TO: TECHNICAL SERVICES COMMITTEE – MONDAY 11 MARCH 2013

SUBJECT: TOWN CAMPS REPORT UPDATE

Trucking Yard – Site visit notes

Inspection Report on Trucking Yards, Larapinta Valley and Hidden Valley Community Road Pavements

Smith Street looking West.

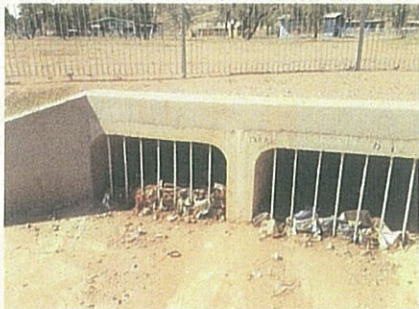
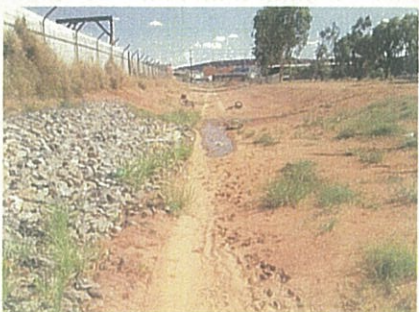
- Intersection still not upgraded.
- Road signage damaged.
- Traffic management – does not exist.

Entrance Road into Camp.

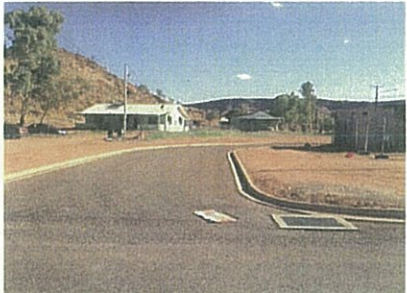
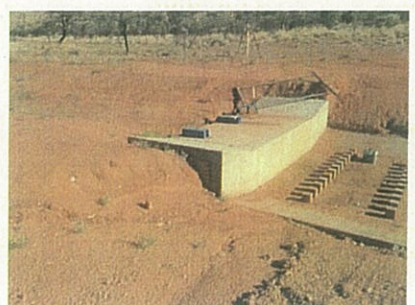
- Significant silt on road
- Dust stains indicates possible ponding of stormwater due to poor grading.

Road entrance to the Camp

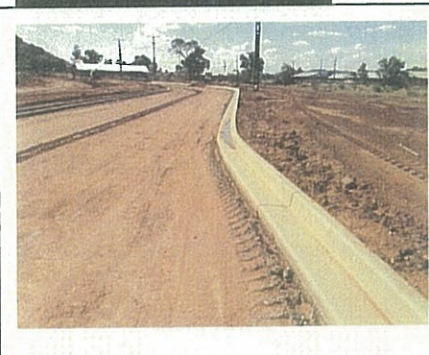
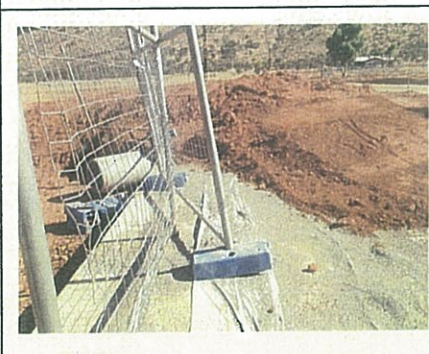
- Roadworks is incomplete
- No kerbs or stormwater infrastructure

Road still under construction – at Sub-grade stage.

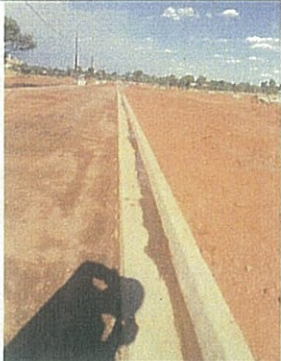
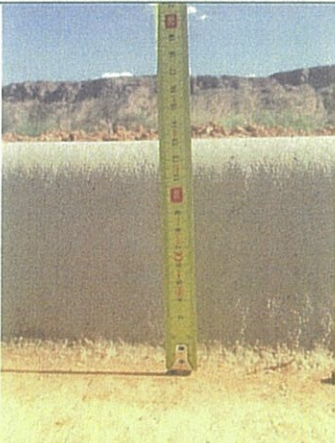
Kerb type is not line with council standard.

Quarry rubble being placed under kerb.
Note the existing sub-grade under pavement is wet and will be an issue with pavement.
